Request of Proposal – Addendum 1

For: Farmers Market

Date: 8/26/2016

TOWN OF MONCKS CORNER – FARMER'S MARKET

3 A100 Bollard Detail
SCALE: 1" = 1'-0"

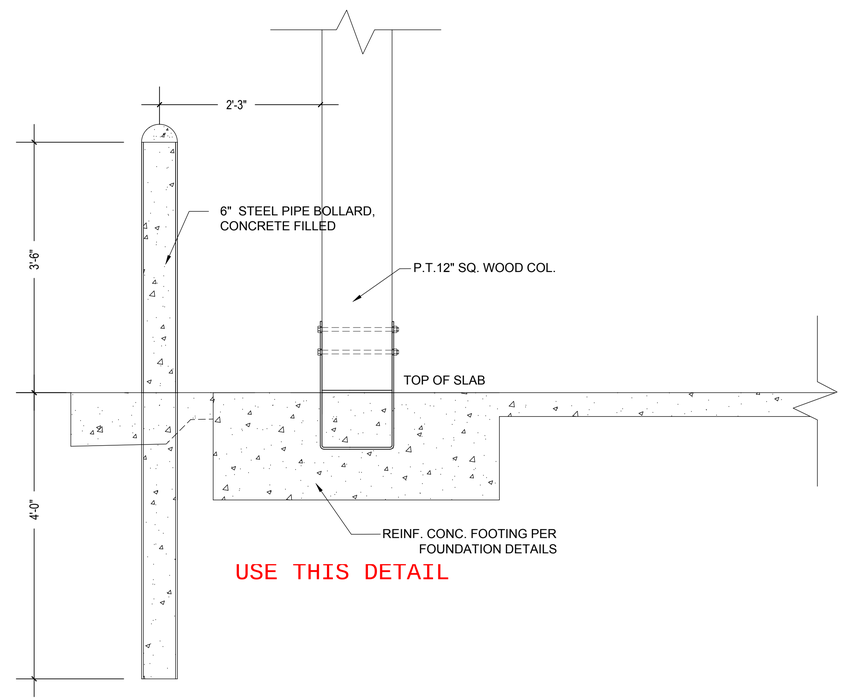
- Bollards to be installed in footing per spec on A100
- Doors to be exterior metal flat panel, knock down frame, with handicap levers and automatic closers.
- Vegetation to be removed by contractor and existing grade to be maintained.
- Concrete testing performed by company TBD per owner.

1 / A200 North Elevation
SCALE: 3/16" = 1'-0"

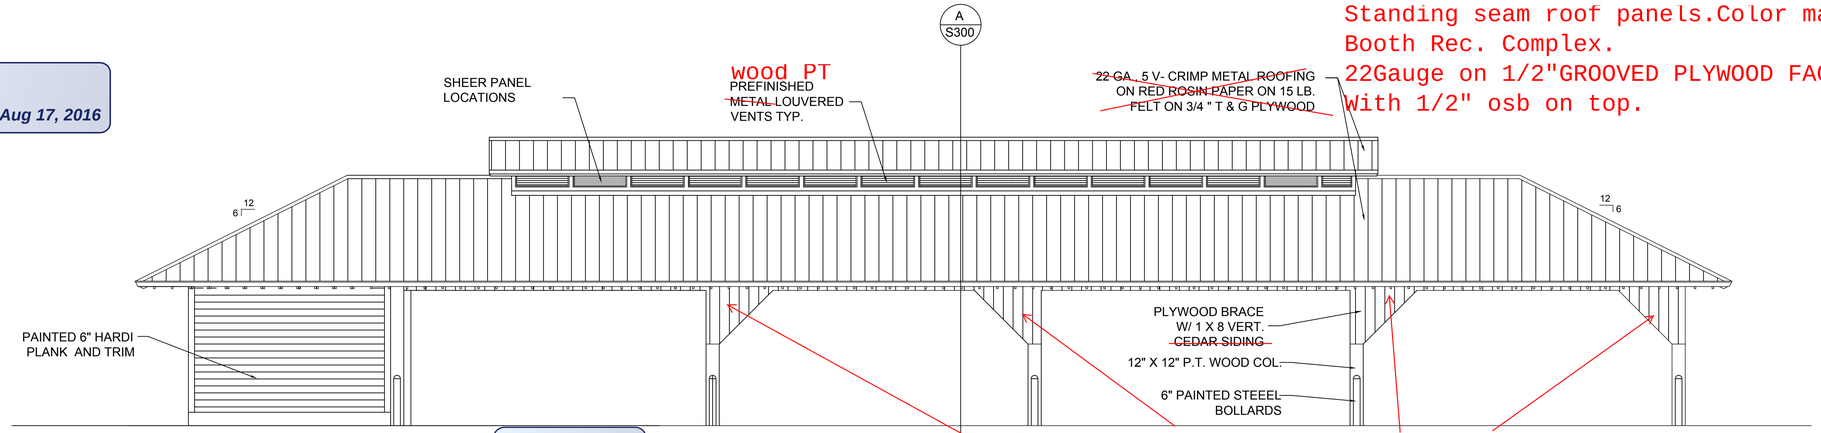
- Paint colors to match ticket booth at REC CENTER.
- Vertical siding pictured to be Cementous siding ILO cedar; joints butt with Cementous trim piece vertically and painted same as building.

Standing seam roof panels.Color match Ticket Booth Rec. Complex.
22Gauge on 1/2"GROOVED PLYWOOD FACE DOWN.
With 1/2" osb on top.

- Siding with vertical hardi butt pieces and place trim over edges(grooves to be vertical)

2 / A200 South Elevation
SCALE: 3/16" = 1'-0"

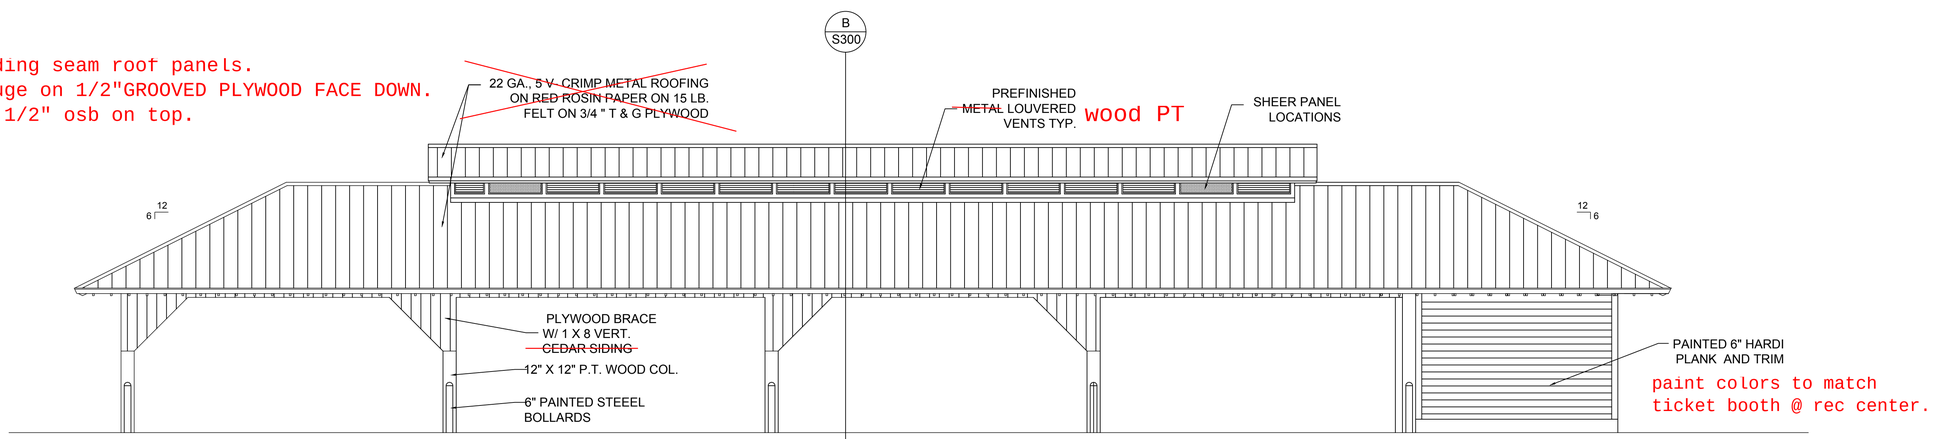
Standing seam roof panels.
22Gauge on 1/2"GROOVED PLYWOOD FACE DOWN.
With 1/2" osb on top.

paint colors to match ticket booth @ rec center.

3 / A200 West Elevation
SCALE: 3/16" = 1'-0"

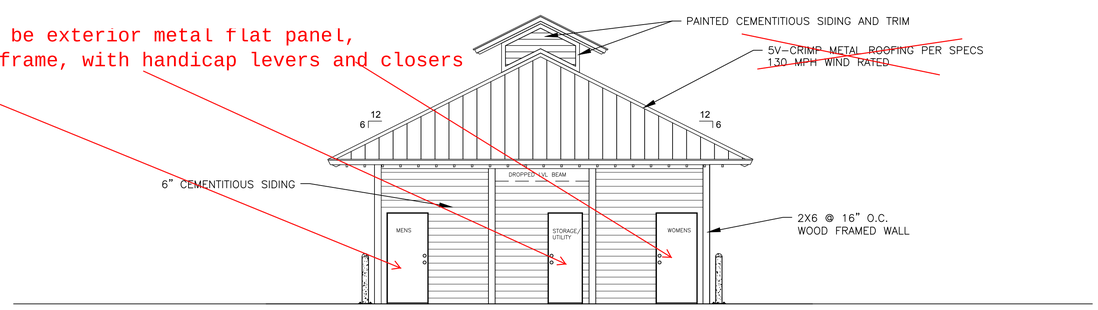
Standing seam roof panels. Color match Ticket Booth Rec. Complex.
22Gauge on 1/2"GROOVED PLYWOOD FACE DOWN.
With 1/2" osb on top. 140 mph

- Doors to be exterior metal flat panel, knock down frame, with handicap levers and closers

4 / A200 East Elevation
SCALE: 3/16" = 1'-0"

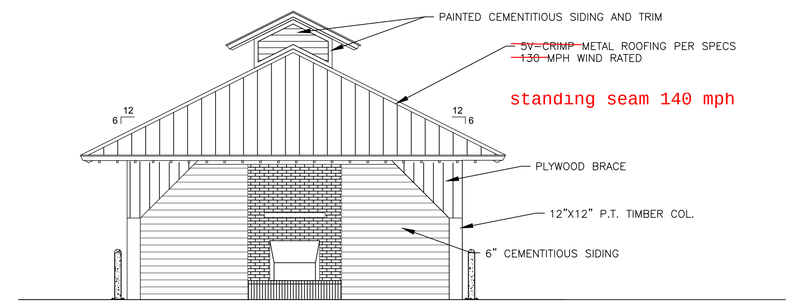
- Brick for fireplace to match ticket booth at REC CENTER.
- Fire extinguishers and safety cabinets will be provided by owner, but contractor installed.

- Brick to match ticket booth at same location.

C / S301 SECTION C-C
SCALE: 3/8" = 1'-0"

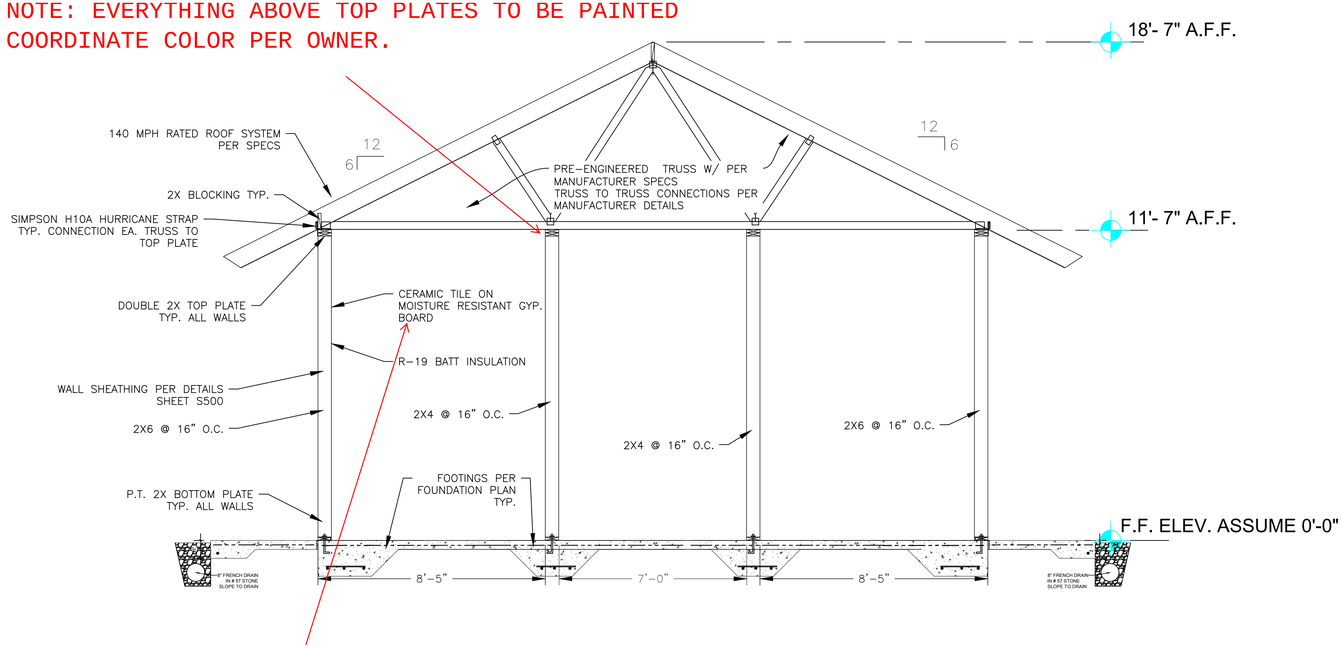
NOTE: EVERYTHING ABOVE TOP PLATES TO BE PAINTED
COORDINATE COLOR PER OWNER.

NOTE: white subway tile 4"x6" to be installed floor to ceiling

ELECTRICAL PLAN
SCALE $\frac{1}{4}$"=1'

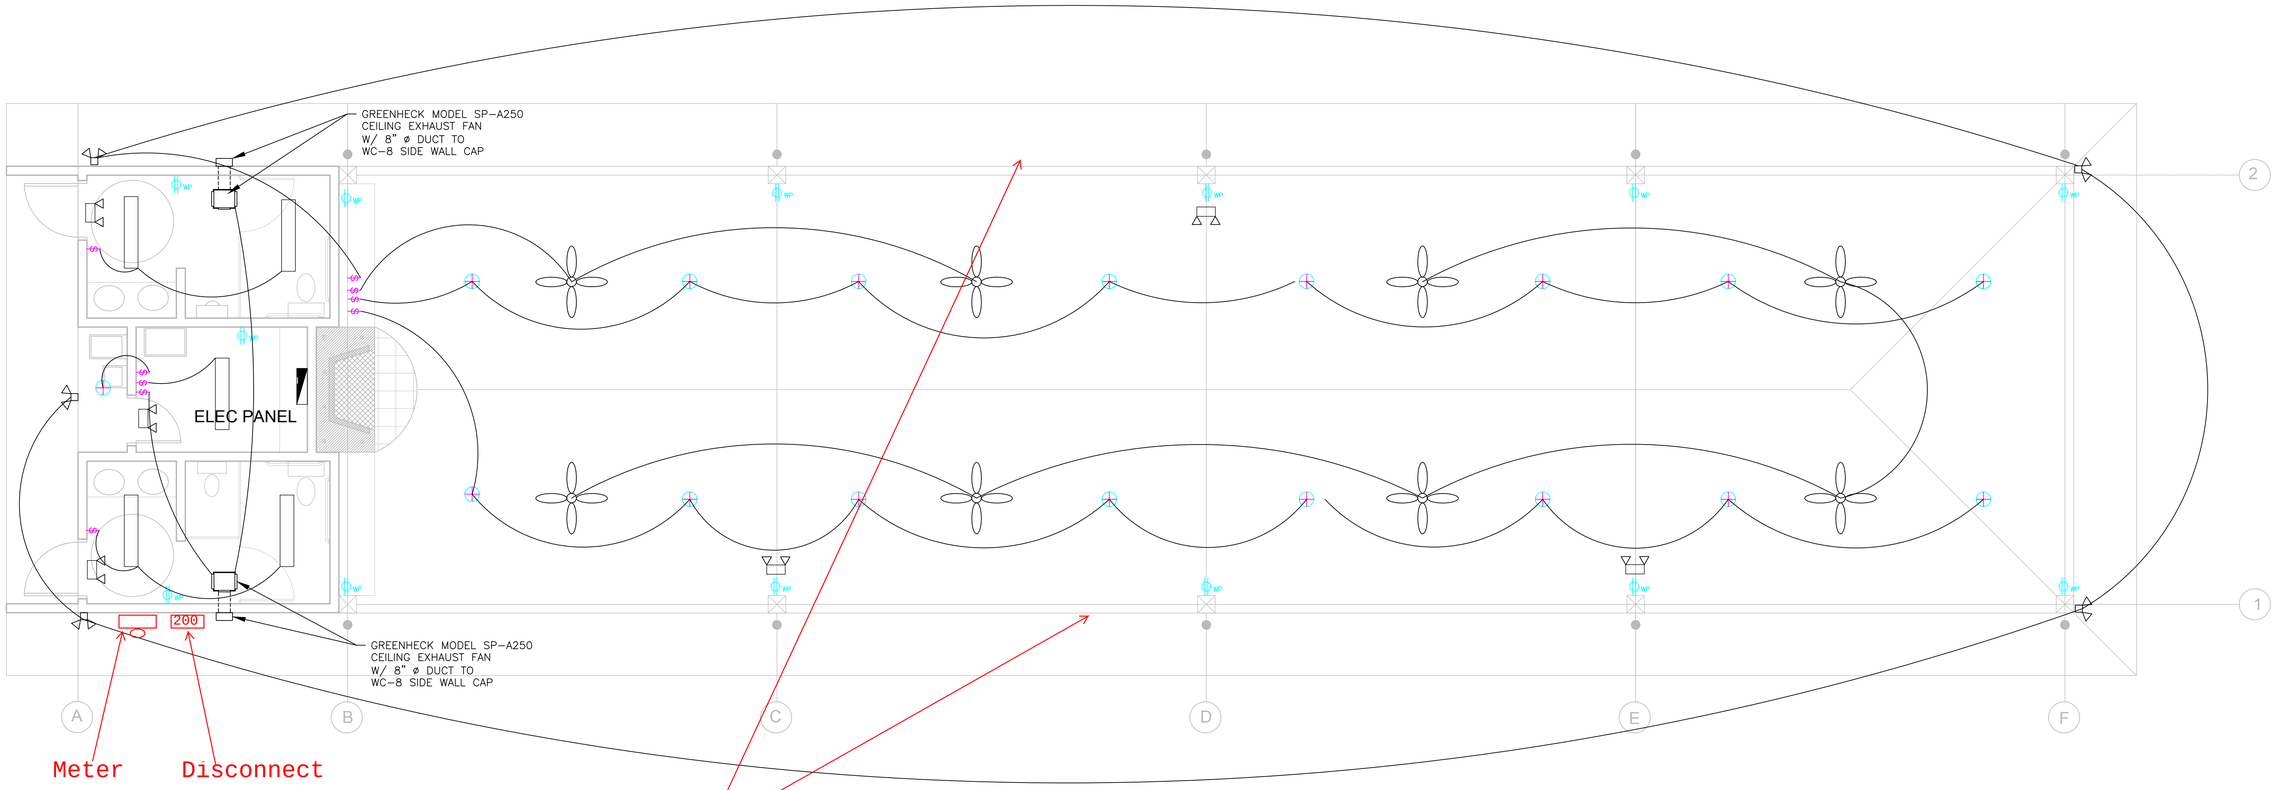
- 200 amp Electrical meter and 200 amp main breaker disconnect to be installed on the outside of bathroom wall, with a 2.5" conduit under concrete to 200 amp 42 circuit panelboard in room on page E100.

- 3" schedule 40 conduit to be run by contractor from meter base to transformer located at front of farmers market. Coordinate stub piping with Santee Cooper. Use long sweep 90 degree elbows for all bends.

- Ceiling fans to be owner provided, contractor installed.
- Electrical panel to be 200 amp 120/240V 42 space. meter and disconnect to be on outside of structure. Trench work from transformer to meter base with 3" conduit to be installed by Contractor. Coordinate stub up with Santee Cooper. All bends to be 90 degree "long sweep".
- Evenly spaced 3 per side fixture choice by owner.

PLUMBING PLAN
SCALE $\frac{1}{4}$"=1'

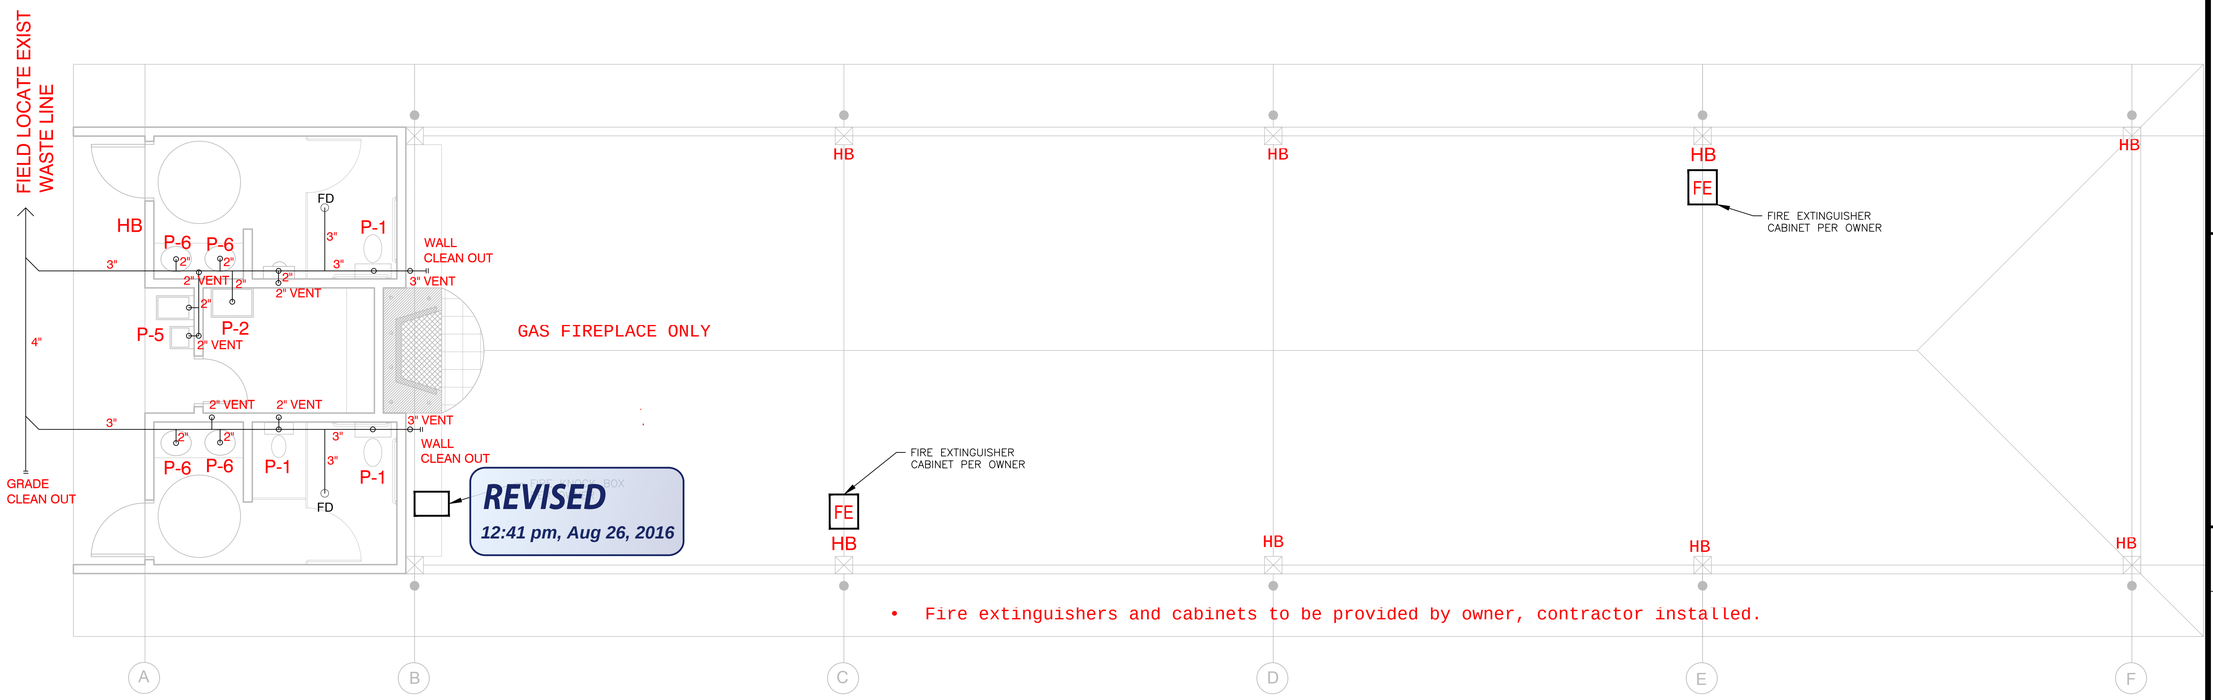
- The P-3 shower referenced on M100 in the legend will not be installed.
- All hose bibs to be installed on the inside of each column post with a galvanized sleeve large enough to allow for the PEX tubing plus R-2 value insulation to be applied before bibb. Fasten steel sleeve to columns.

• Fire extinguishers and cabinets to be provided by owner, contractor installed.

P-1	ADA WATER CLOSET
P-2	FIBERGLASS UTILITY SINK
~~P-3~~	~~36" X 36" FIBERGLASS SHOWER UNIT~~ REMOVE
P-4	ADA URINAL
P-5	ADA DRINKING FOUNTAIN
P-6	ADA LAVATORY Wall hung, porcelein sinks
FD	3" FLOOR DRAIN
	BELOW GRADE WASTE LINES TO BE SCHEDULE 40 PVC
HB	TAMPLE RESISTANT HOSE BIB W/ 1/2 INSULATED PEX POTABLE WATER LINE

• All hose bibs to be installed on inside of post from underground PEX (Provide galvanized sleeve large enough for foam insulation.
